Subject: Response to DMS Comments for DRAFT Monitoring Year 3 Report
Thomas Creek Restoration Project, Wake County
DMS Project # 96074, DEQ Contract #5549, RFP# 16-005020

FINAL

Thomas Creek Restoration Project

Year 3 Monitoring Report

Figure 6. Year 3 Cross-sections

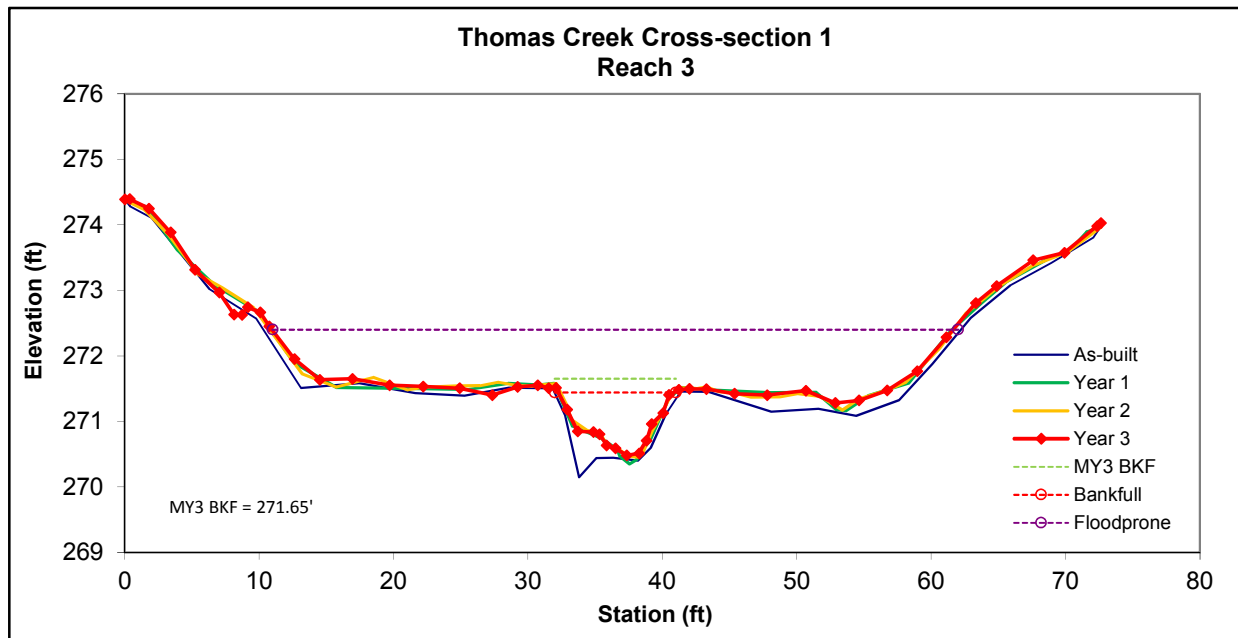
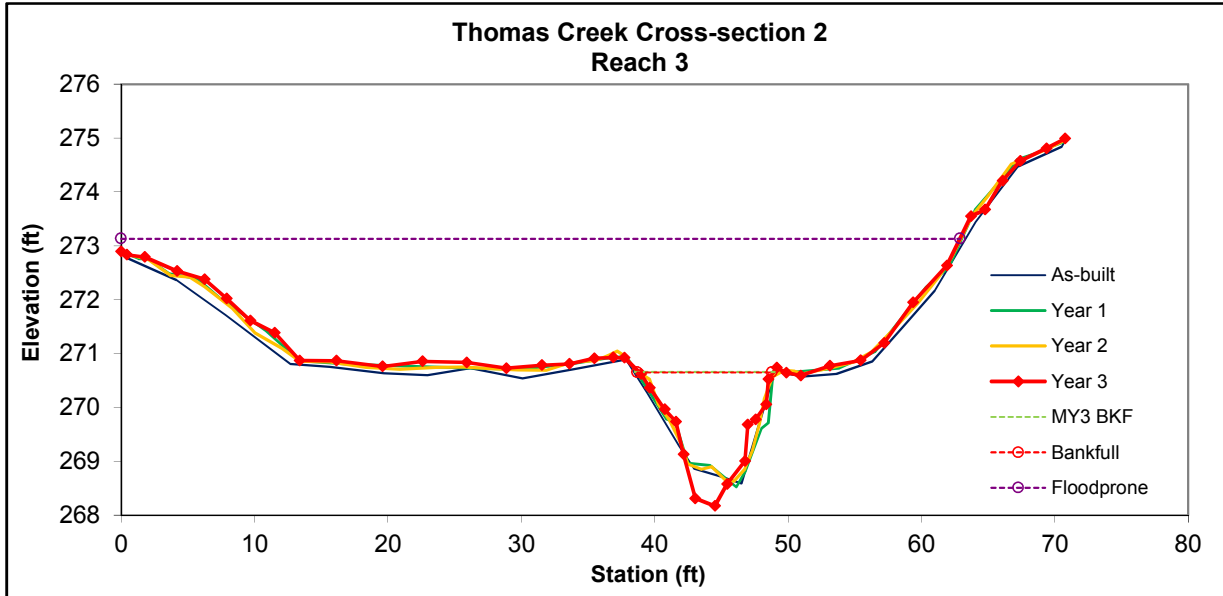
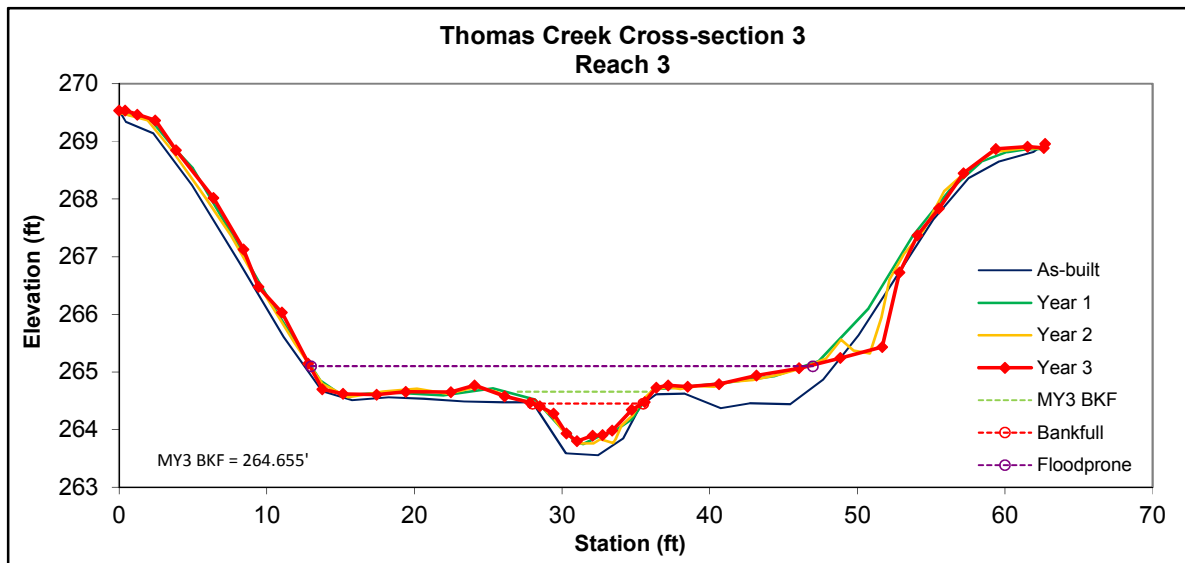
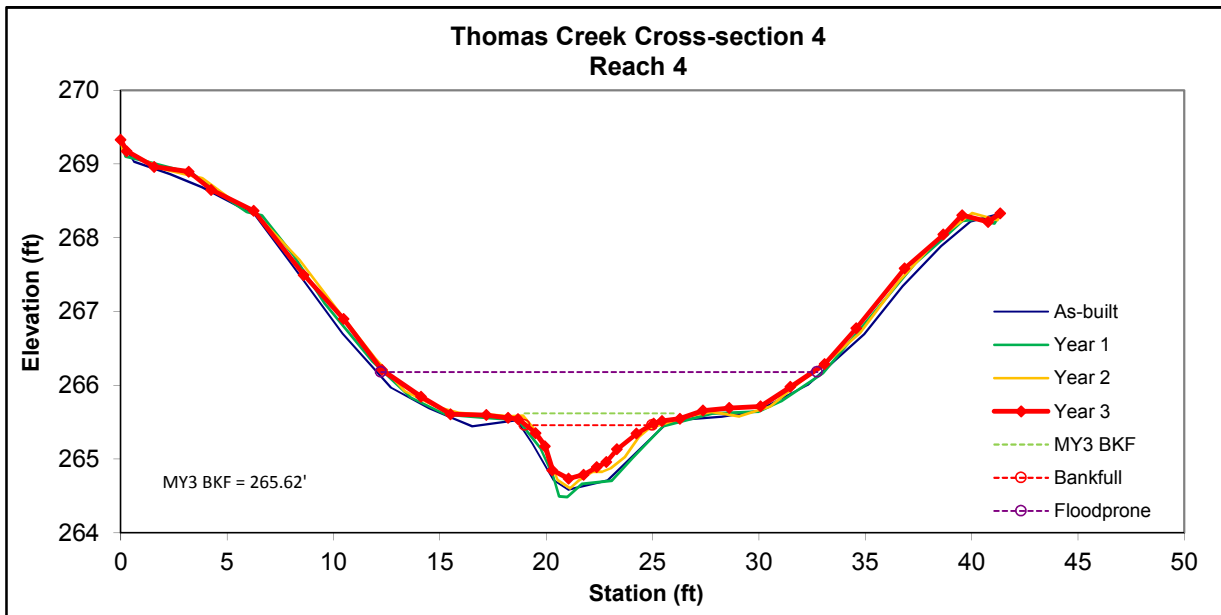
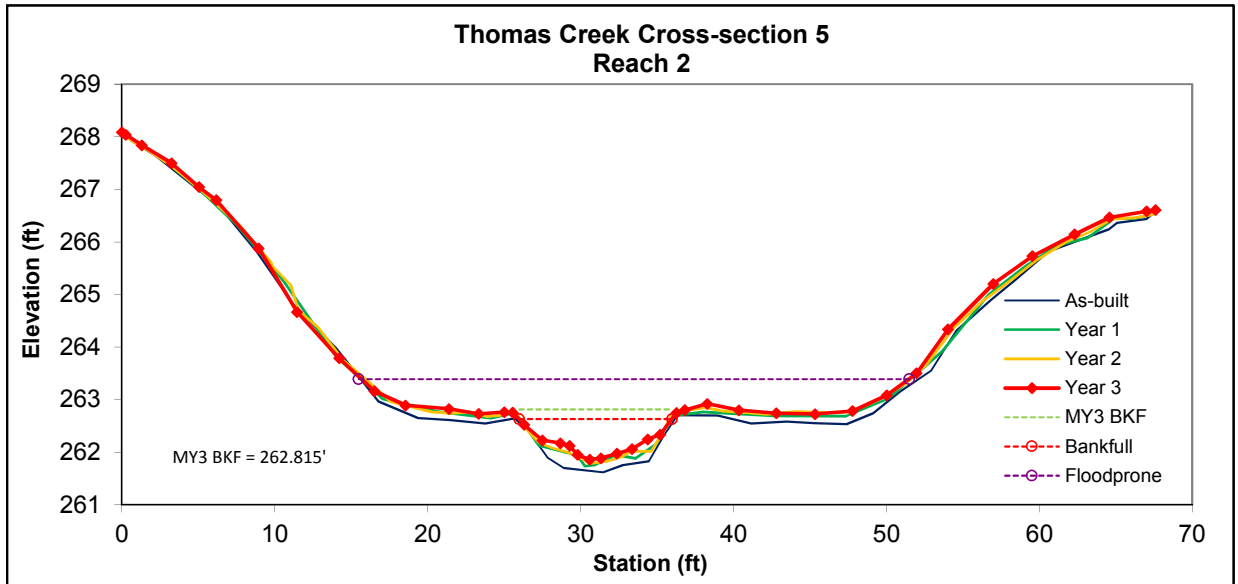
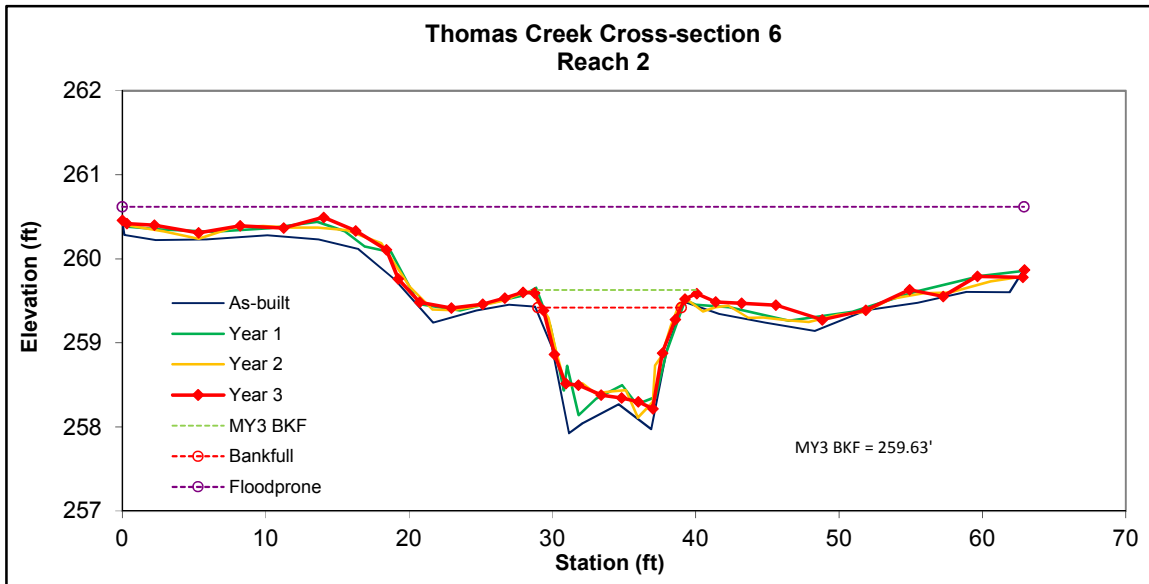
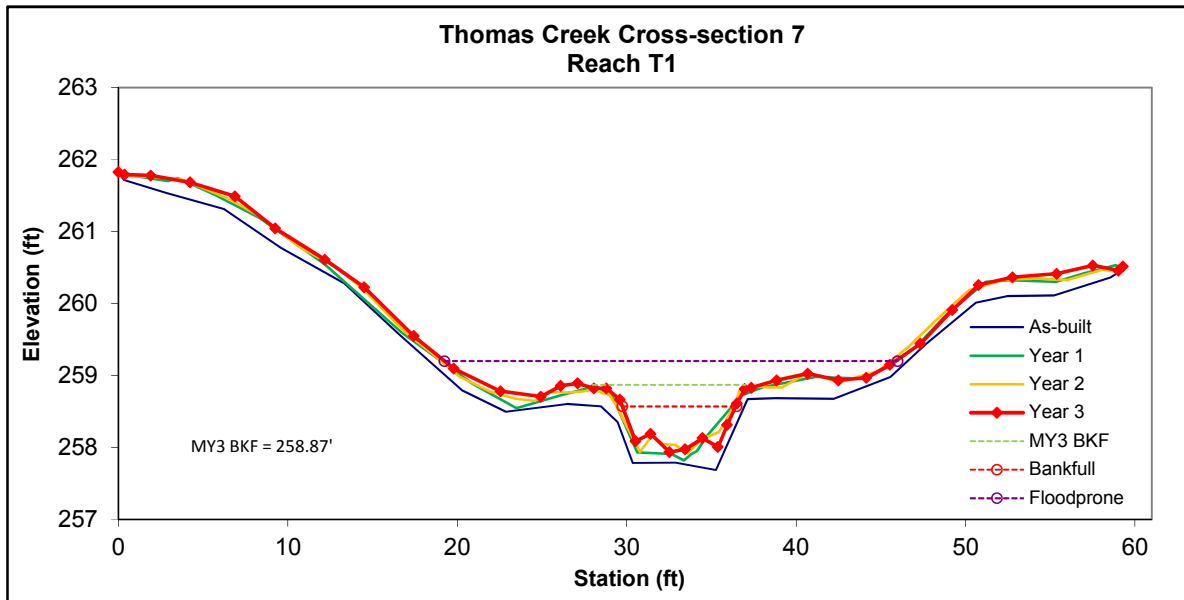
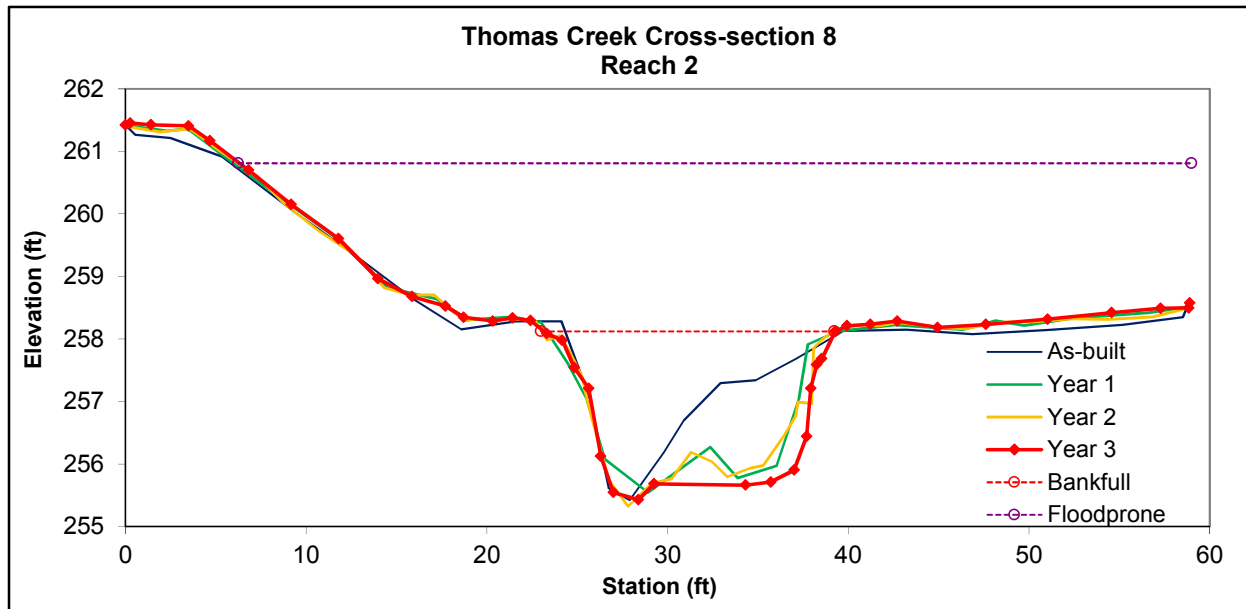
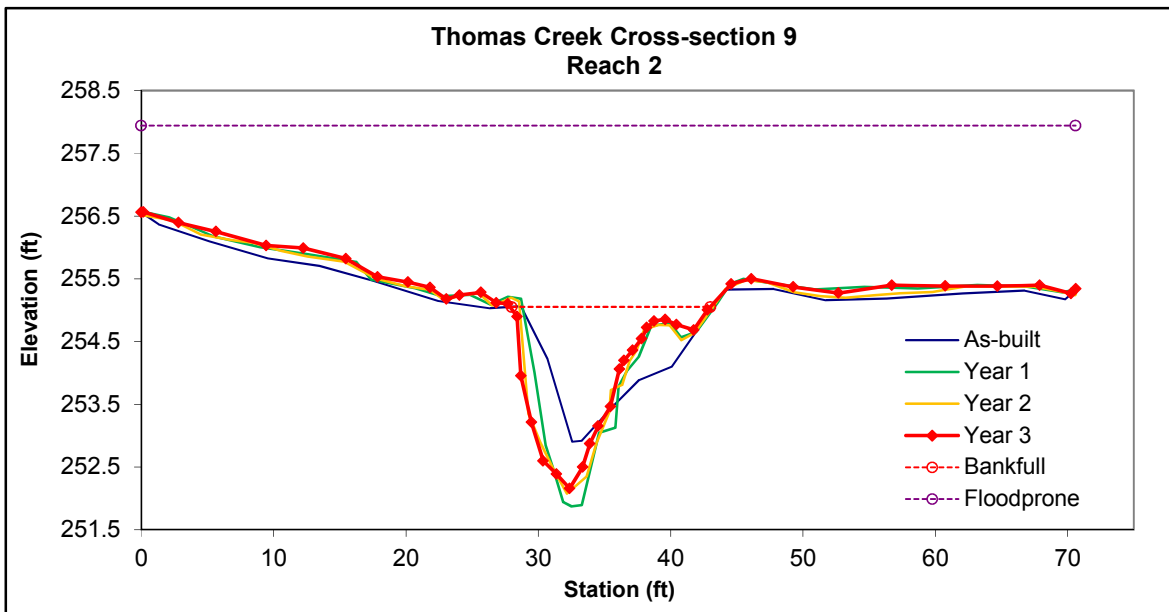
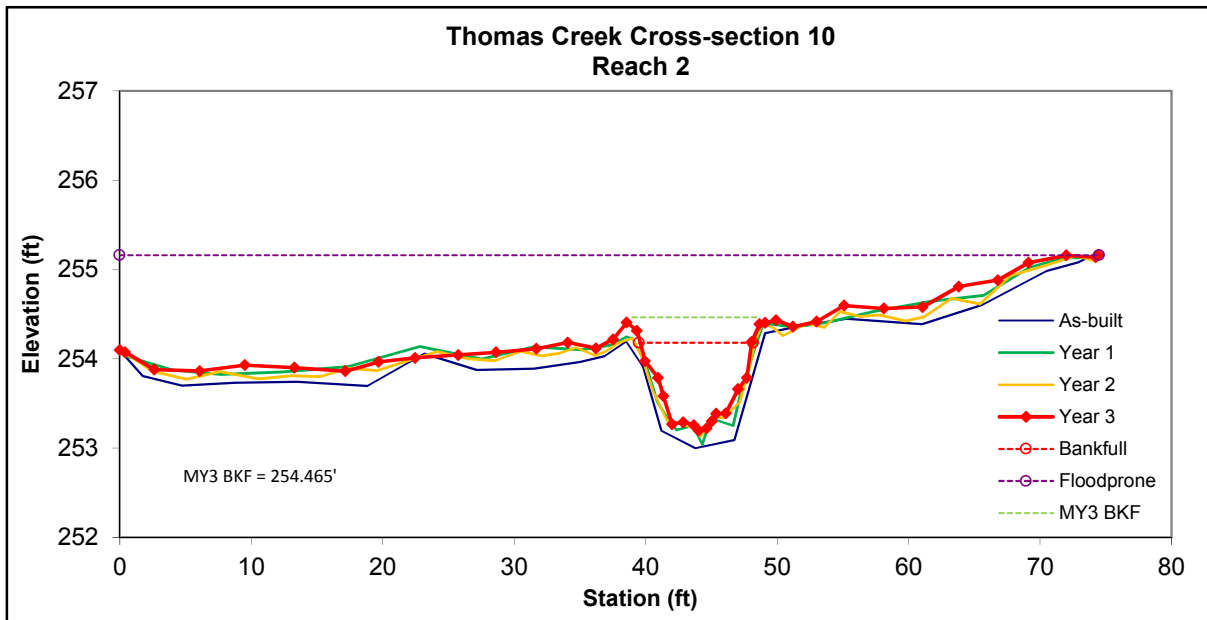
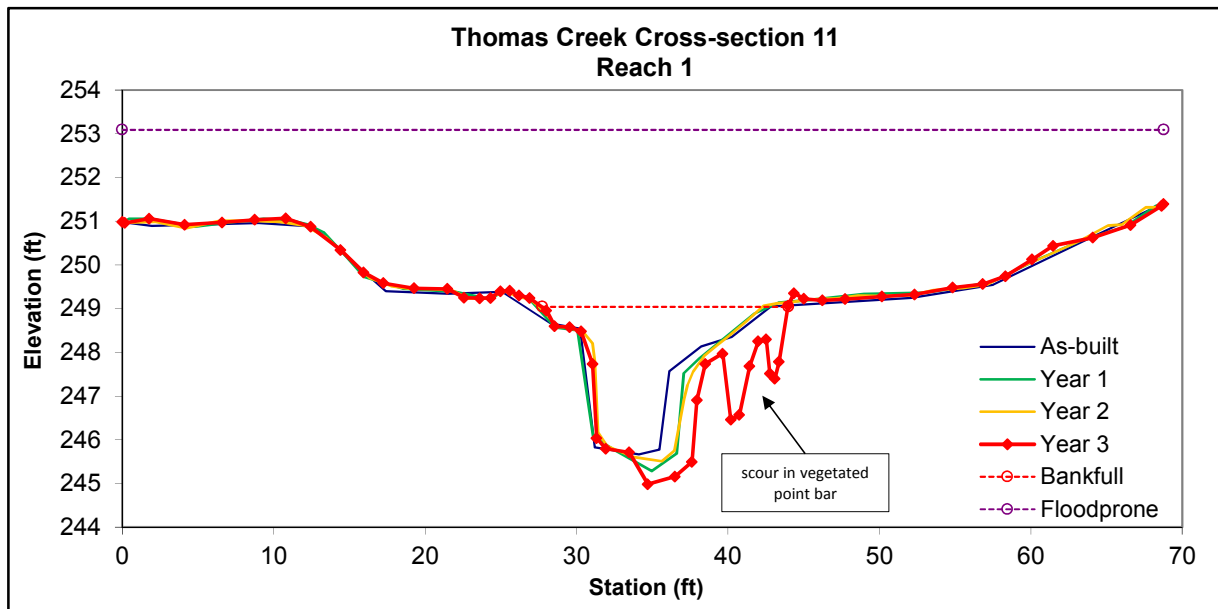
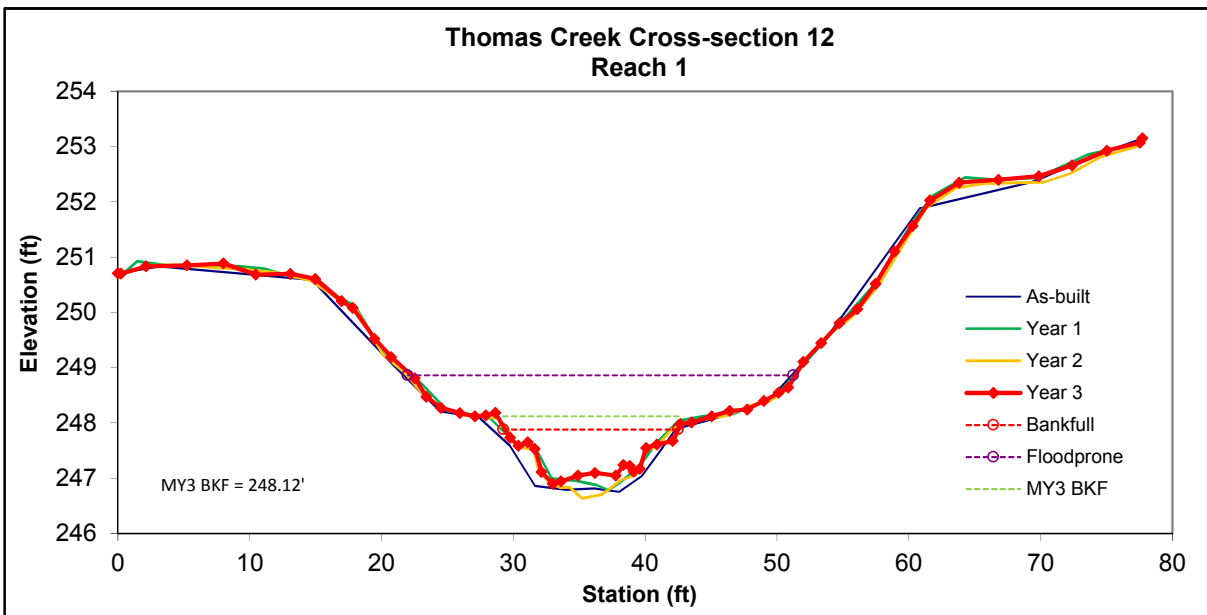
4. Appendix D, Table 11: During our review of the Bank Height Ratios (BHR) in Table 11, DMS staff performs a visual comparison of the MY3 data to As-Built/Baseline cross-sections. DMS noted/realized that by displaying the As-built Bankfull Cross-Sectional Area alone, the calculation for the BHR can be difficult to reconcile. We noted possible discrepancies in the BHR calculations for cross-sections 1, 3, 4, 5, 6, 7, 10, 12, 13 and 14 given this disconnect. Using the new BHR calculation methodology where the As-Built Bankfull Area is held constant, please display the Year 3 bankfull elevation as another data series just for the sake of clarity between the BHR calculation and the overlay. It appears that the BHR calculations were done correctly, but just please add the MY3 bankfull data series with its elevation for the sake of clarity to the reader.

Response: An additional data series was added to each cross-section figure showing the MY3 bankfull line (generated using the as-built bankfull area as per the recent DMS memo) as requested. The BHR calculations for the listed cross-sections were re-checked again and were all confirmed as correct. With the new bankfull line shown, a visual comparison between it and the MY3 cross-section data certainly makes the BHR value appear to make intuitive sense.
